Errata for the FT-1000MP Operating Manual

The following information outlines some corrections that are needed to be made in the operating instructions for the FT-1000MP manual. You can keep this as a reference, or else make the changes to the appropriate sections of the manual by marking in corrections, as needed. We apologize for this inconvenience, and appreciate your patience and understanding.

PACKET jack pinout

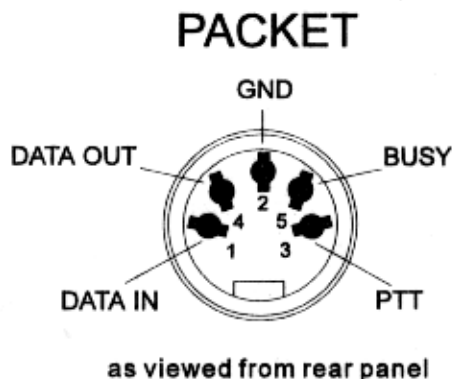
The pin connection information for the rear-panel **PACKET** jack is incorrect as it appears on pages 4 and 53. The correct pin-out sequence is shown below:
